Figure 7B-1. Signs in School Areas and at School Crossings (Sheet 1 of 2)

Summary of Comments on CAMUTCD 2026 7B Fig.pdf

Summary of Comments on Part 7B Figure CA MUTCD 2026

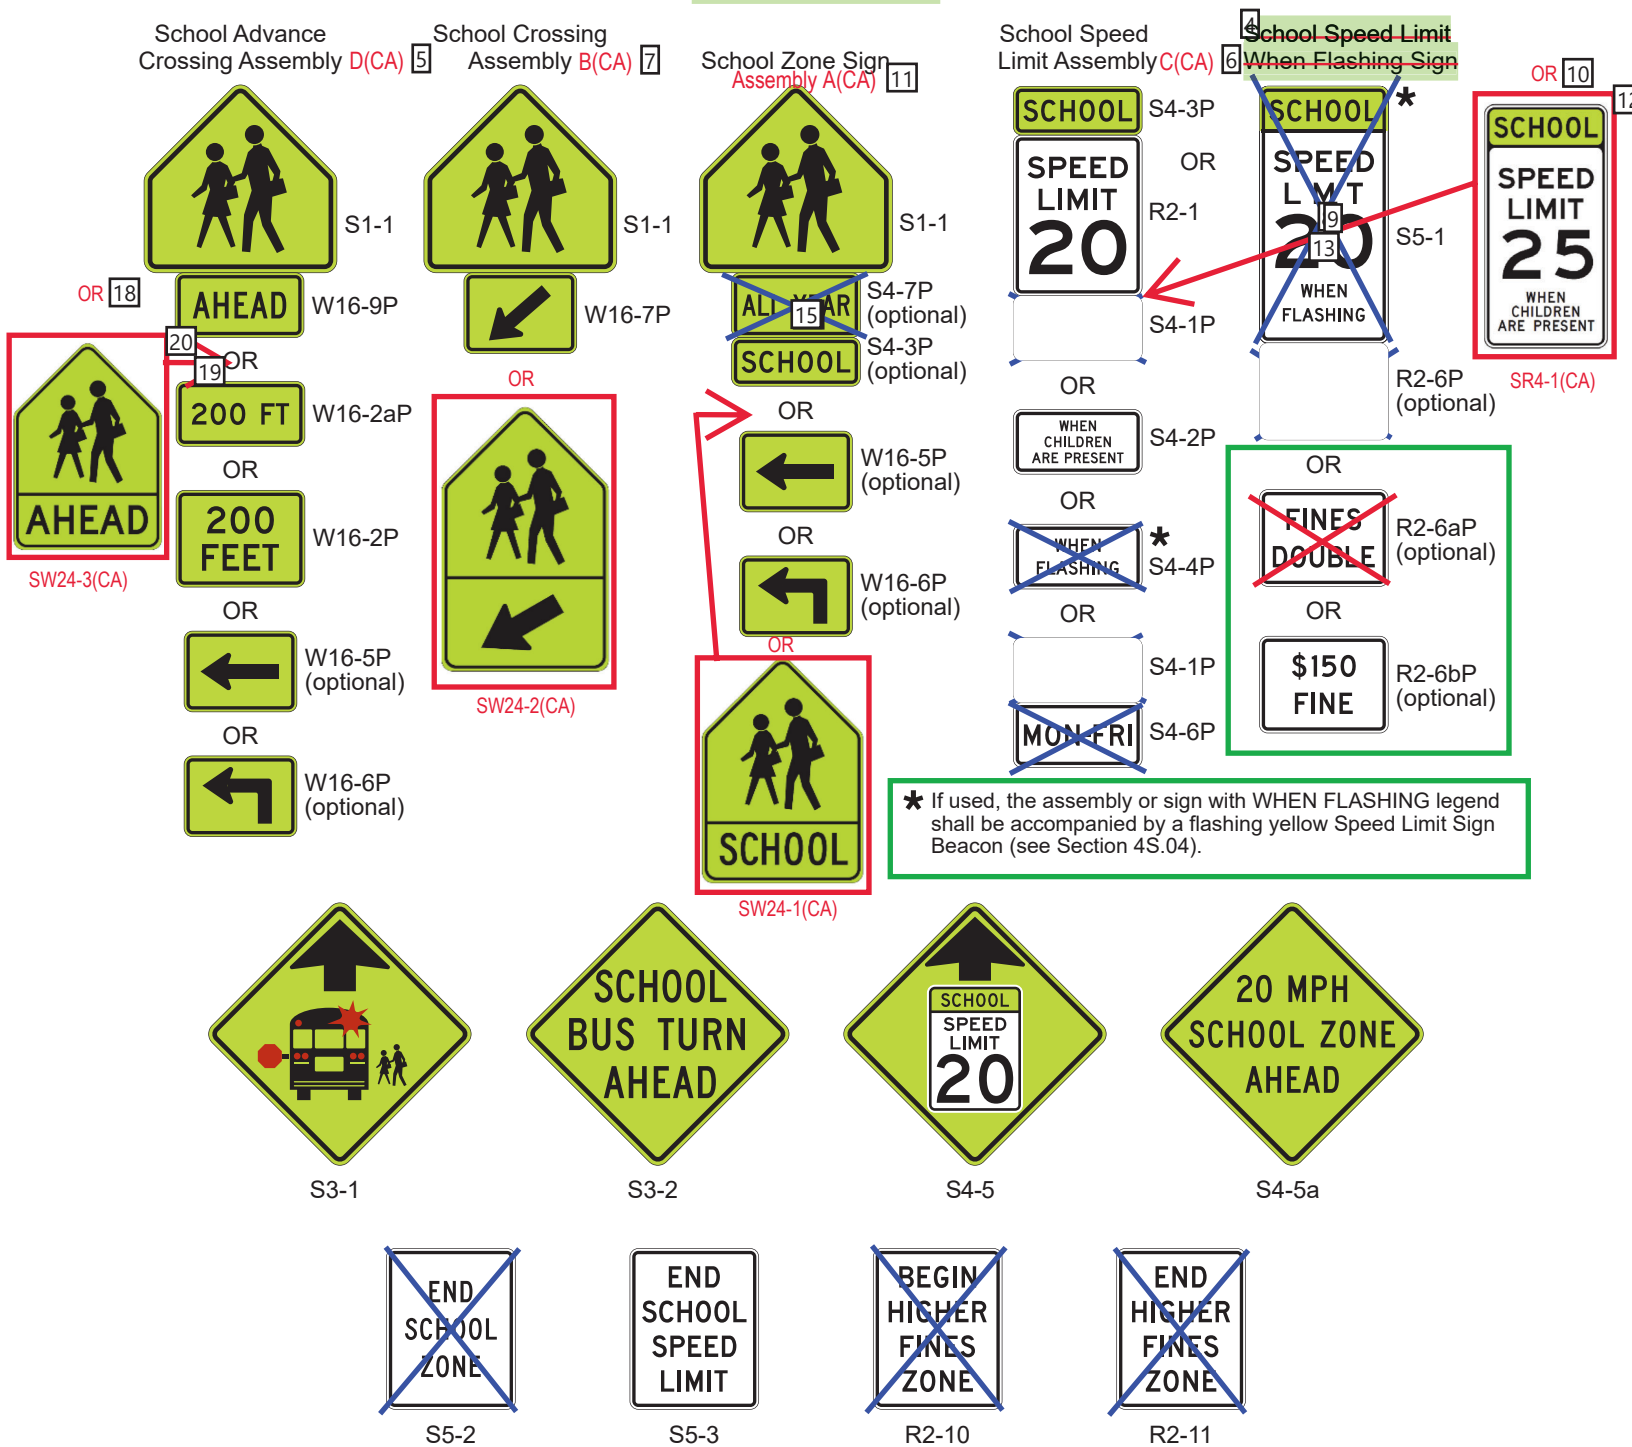
Number: 1	Author: s116730	Subject: Highlight	Date: 7/25/2024 9:46:00 AM
NMUTCD 2023 changed the title of Figure 7B-1 from "School Area Signs" to "Signs in School Areas and at School Crossings" and incorporated signs from NMUTCD 2009 Figures 7B-1 and 7B-6 and added sub-headings A thru D, expanding Figure 7B-1 into 2 sheets.				
NMUTCD 2023 added sign codes for all signs, which were missing in NMUTCD 2009 figures				
	Number: 2	Author: s116730	Subject: Highlight	Date: 7/25/2024 9:46:06 AM
NMUTCD 2023 added sub-heading A				
	Number: 3	Author: s116730	Subject: Cross-Out	Date: 7/8/2024 11:11:18 AM
	Number: 4	Author: s116730	Subject: Highlight	Date: 7/25/2024 9:46:13 AM
NMUTCD 2023 added new text				
	Number: 5	Author: s116730	Subject: Text Box	Date: 7/9/2024 3:32:56 PM
D(CA)				
	Number: 6	Author: s116730	Subject: Text Box	Date: 7/9/2024 4:02:20 PM
C(CA)				
	Number: 7	Author: s116730	Subject: Text Box	Date: 7/9/2024 3:33:04 PM

Number: 20	Author: s116730	Subject: Rectangle	Date: 7/9/2024 3:56:19 PM
Add SW24-3(CA) image in Assembly D(CA) between the W16-9P and W16-2aP				
	Number: 21	Author: s116730	Subject: Line	Date: 7/8/2024 11:12:25 AM
	Number: 22	Author: s116730	Subject: Line	Date: 7/8/2024 11:12:17 AM

Figure 7B-1. Signs in School Areas and at School Crossings (Sheet 1 of 2)

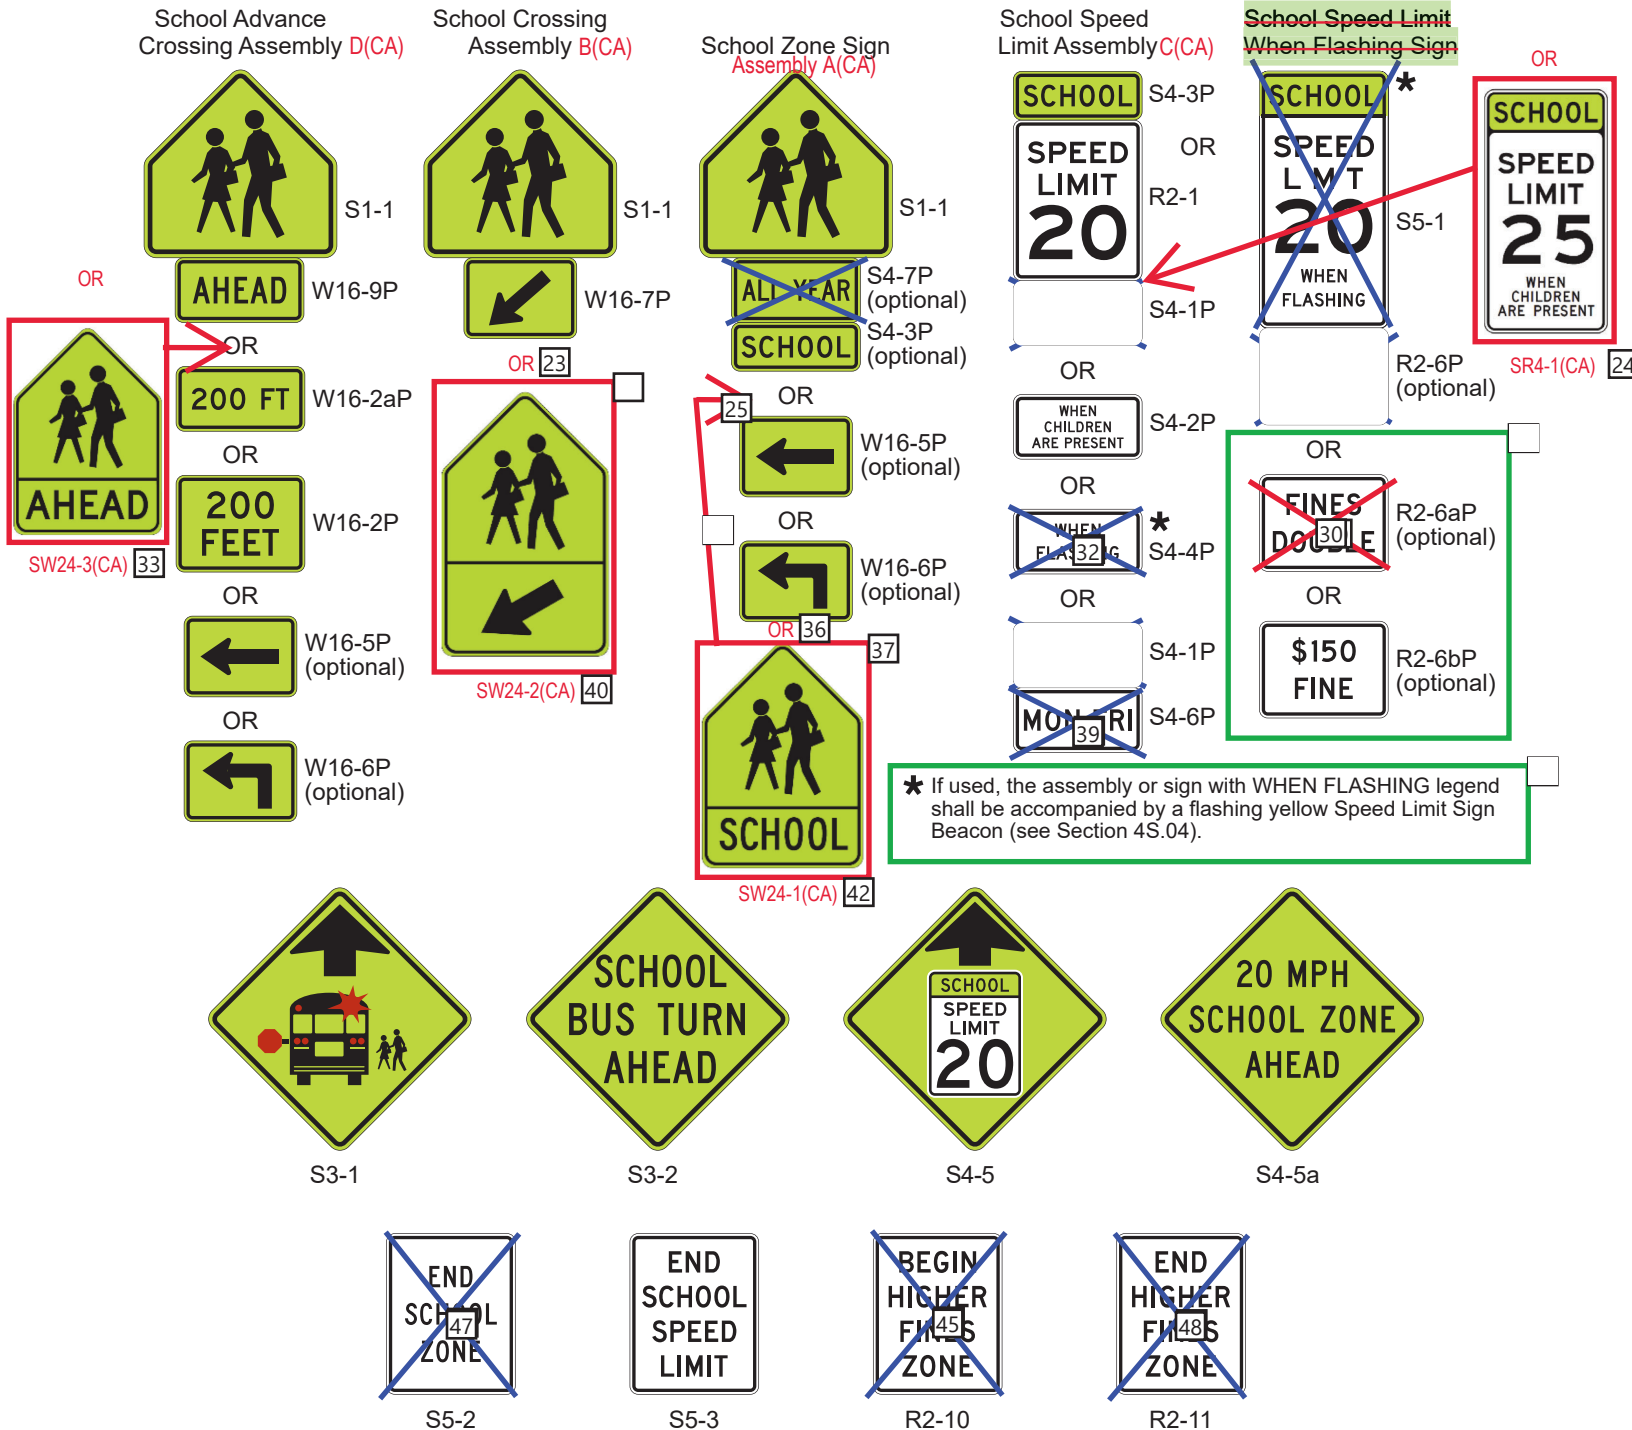
Number: 23	Author: s116730	Subject: Text Box	Date: 7/9/2024 3:57:09 PM
OR				
	Number: 24	Author: s116730	Subject: Text Box	Date: 7/9/2024 4:04:01 PM
SR4-1(CA)				
	Number: 25	Author: s116730	Subject: Line	Date: 7/9/2024 4:07:36 PM
	Number: 26	Author: s116730	Subject: Rectangle	Date: 7/9/2024 3:59:42 PM
Add SW24-2(CA) image in Assembly D(CA) below the W16-7P				
	Number: 27	Author: s116730	Subject: Line	Date: 7/9/2024 4:06:50 PM
	Number: 28	Author: s116730	Subject: Rectangle	Date: 7/13/2024 10:03:54 AM
NMUTCD 2023 added new signs				
	Number: 29	Author: s116730	Subject: Line	Date: 7/8/2024 11:16:39 AM
	Number: 30	Author: s116730	Subject: Line	Date: 7/8/2024 11:16:39 AM
	Number: 31	Author: s116730	Subject: Line	Date: 7/8/2024 10:57:28 AM
	Number: 32	Author: s116730	Subject: Line	Date: 7/8/2024 10:57:13 AM
	Number: 33	Author: s116730	Subject: Text Box	Date: 7/9/2024 3:56:26 PM
SW24-3(CA)				
	Number: 34	Author: s116730	Subject: Line	Date: 7/8/2024 10:58:34 AM

Number: 35	Author: s116730	Subject: Line	Date: 7/8/2024 10:58:34 AM
	Number: 36	Author: s116730	Subject: Text Box	Date: 7/9/2024 3:57:52 PM
OR				
	Number: 37	Author: s116730	Subject: Rectangle	Date: 7/9/2024 3:47:20 PM
Add SW24-1(CA) image in Assembly A(CA) between the S4-3P and W16-5P				
	Number: 38	Author: s116730	Subject: Line	Date: 7/8/2024 10:58:51 AM
	Number: 39	Author: s116730	Subject: Line	Date: 7/8/2024 10:58:51 AM
	Number: 40	Author: s116730	Subject: Text Box	Date: 7/9/2024 3:58:56 PM
SW24-2(CA)				
	Number: 41	Author: s116730	Subject: Rectangle	Date: 7/13/2024 10:04:44 AM
NMUTCD 2023 added new note				
	Number: 42	Author: s116730	Subject: Text Box	Date: 7/9/2024 3:57:21 PM
SW24-1(CA)				
	Number: 43	Author: s116730	Subject: Line	Date: 7/8/2024 11:13:52 AM
	Number: 44	Author: s116730	Subject: Line	Date: 7/8/2024 11:13:18 AM
	Number: 45	Author: s116730	Subject: Line	Date: 7/8/2024 11:13:52 AM

Figure 7B-1. Signs in School Areas and at School Crossings (Sheet 2 of 2)

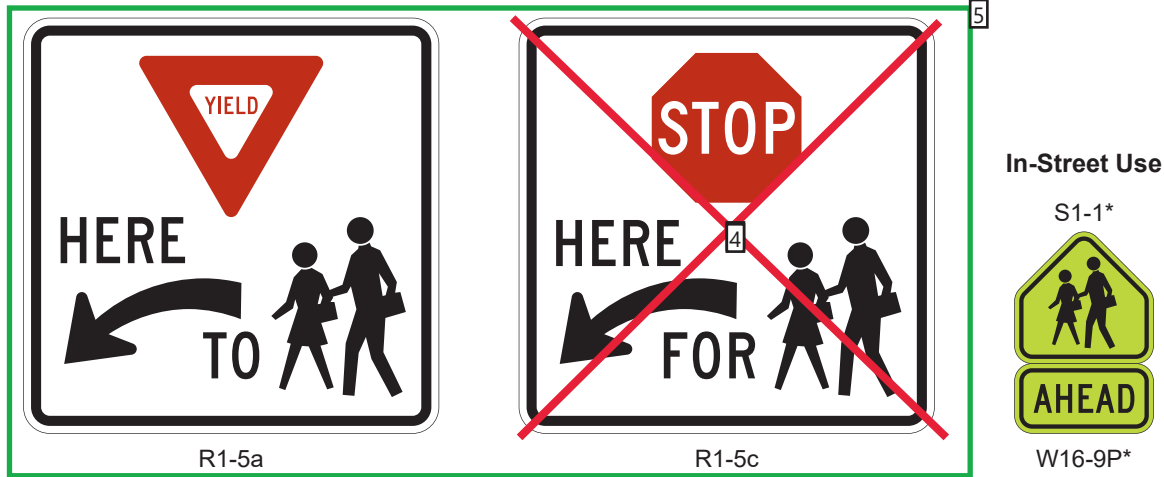
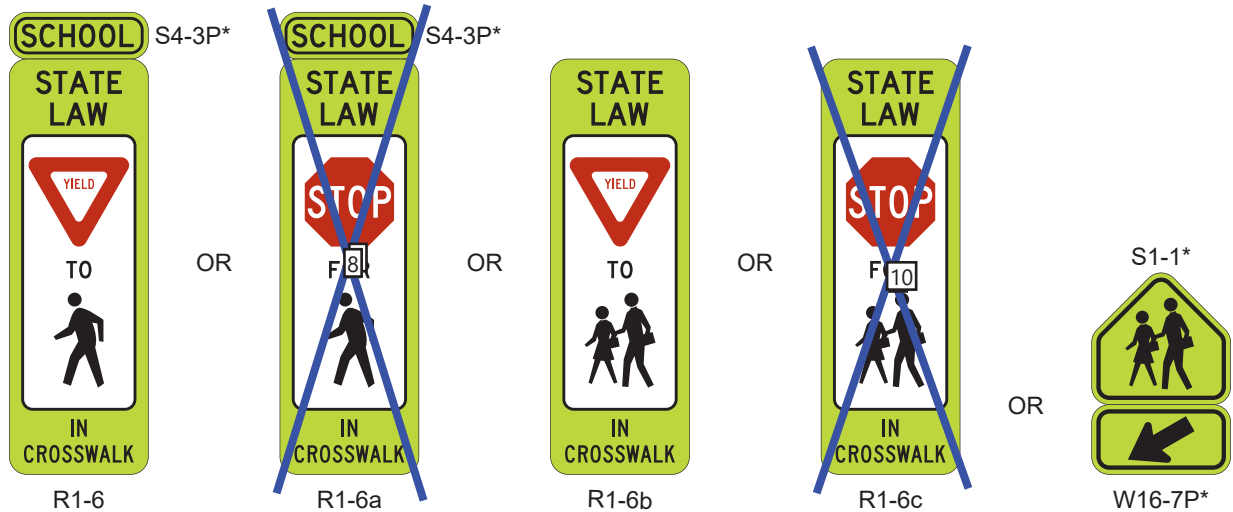
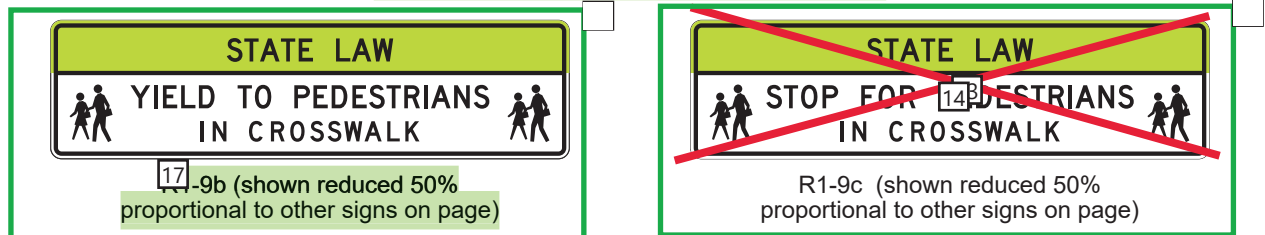
Number: 1	Author: s116730	Subject: Highlight	Date: 7/25/2024 9:46:47 AM
NMUTCD 2023 changed the title of Figure 7B-1 from "School Area Signs" to "Signs in School Areas and at School Crossings" and incorporated signs from NMUTCD 2009 Figures 7B-1 and 7B-6 and added sub-headings A thru D, expanding Figure 7B-1 into 2 sheets.				
NMUTCD 2023 added sign codes for all signs, which were missing in NMUTCD 2009 figures				
	Number: 2	Author: s116730	Subject: Highlight	Date: 7/25/2024 9:46:51 AM
NMUTCD 2023 changed sub-heading A in NMUTCD 2009 Figure 7B-6 to B				
	Number: 3	Author: s116730	Subject: Line	Date: 7/10/2024 8:44:02 AM
	Number: 4	Author: s116730	Subject: Line	Date: 7/10/2024 8:44:02 AM
	Number: 5	Author: s116730	Subject: Rectangle	Date: 7/13/2024 10:07:09 AM
NMUTCD 2023 added new signs				
	Number: 6	Author: s116730	Subject: Highlight	Date: 7/25/2024 9:47:03 AM
NMUTCD 2023 changed sub-heading B in NMUTCD 2009 Figure 7B-6 to C

Number: 7	Author: s116730	Subject: Line	Date: 7/14/2024 8:17:45 AM
	Number: 8	Author: s116730	Subject: Line	Date: 7/14/2024 8:17:45 AM
	Number: 9	Author: s116730	Subject: Line	Date: 7/14/2024 8:17:45 AM
	Number: 10	Author: s116730	Subject: Line	Date: 7/14/2024 8:17:45 AM
	Number: 11	Author: s116730	Subject: Highlight	Date: 7/25/2024 9:47:07 AM
NMUTCD 2023 added sub-heading D				
	Number: 12	Author: s116730	Subject: Text Box	Date: 7/9/2024 4:12:53 PM
Assembly E(CA)				
	Number: 13	Author: s116730	Subject: Line	Date: 7/10/2024 8:46:35 AM
	Number: 14	Author: s116730	Subject: Line	Date: 7/10/2024 8:46:24 AM
	Number: 15	Author: s116730	Subject: Rectangle	Date: 7/13/2024 10:07:36 AM
NMUTCD 2023 added new signs				
	Number: 16	Author: s116730	Subject: Rectangle	Date: 7/13/2024 10:07:27 AM
NMUTCD 2023 added text "IN CROSSWALK" as 3rd line in the sign				
	Number: 17	Author: s116730	Subject: Highlight	Date: 7/25/2024 9:47:24 AM

NMUTCD 2023 changed sign code from R1-9 in NMUTCD 2009 to R1-9b and added this text description.				
	Number: 18	Author: s116730	Subject: Highlight	Date: 7/25/2024 9:47:33 AM
	Number: 19	Author: s116730	Subject: Highlight	Date: 7/25/2024 9:47:28 AM
NMUTCD 2023 added this text in the Note #1. Note #1 previously was in NMUTCD 2009 Figure 7B-6.				
	Number: 20	Author: s116730	Subject: Highlight	Date: 7/25/2024 9:47:38 AM
NMUTCD 2023 added new note

~~Figure 7B-1(CA). School Area Signs (Sheet 2 of 2)~~
Figure 7B-1(CA). Signs in School Areas and at School Crossings

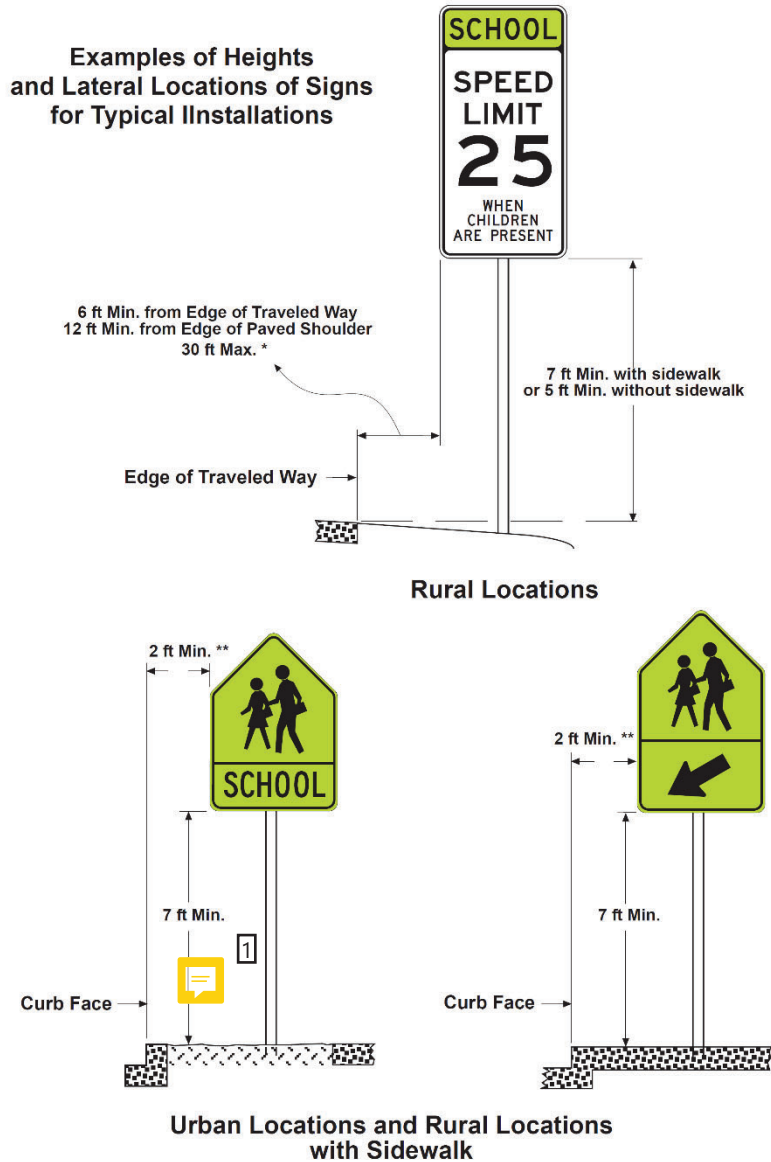
Author: Johnny Bhullar Subject: Sticky Note Date: 3/28/2025 10:05:44 AM
Revise single line text "7 ft. Min." to two line text, with 1st line as "7 ft. Min. (Urban)" and second line as "5 ft. Min. (Rural)"

Author: Johnny Bhullar Subject: Sticky Note Date: 3/28/2025 9:58:53 AM
Add Note:
"A 4-foot minimum unobstructed pedestrian access route should be maintained."

Number: 1 Author: s116730 Subject: Sticky Note Date: 7/16/2024 7:58:04 AM
Figure name changed to match NMUTCD 2023 Figure 7B-1 name and text for "(Sheet 2 of 2)" is deleted.

Number: 3 Author: s116730 Subject: Cross-Out Date: 7/25/2024 9:48:03 AM
NMUTCD 2023 changed the title of Figure 7B-1 from "School Area Signs" to "Signs in School Areas and at School Crossings"
